Appn. No.: 10/567,201
Amendment Dated March 24, 2011
Reply to Office Action of November 24, 2010

ITC-337US

Enclosure: Marked-up Copy of Applicant's Fig. 7

Figure 7

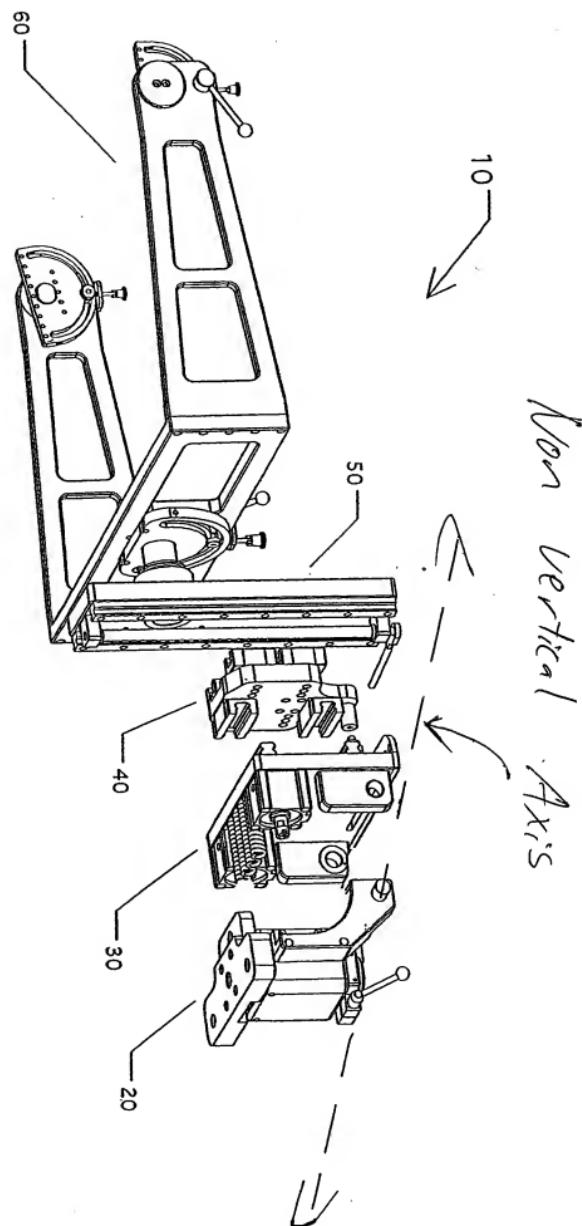
It is noted that the rotative access is related to Applicant's claimed coupling and Applicant's claimed coupling is "between" the first support structure (which provides linear movement) and the second support structure (which provides linear movement). In order to assist the Examiner in understanding Applicant's claim language, a marked-up copy of Applicant's Fig. 7 is enclosed where the "non-vertical axis" is shown. Of course, this is merely an exemplary embodiment of the present invention.
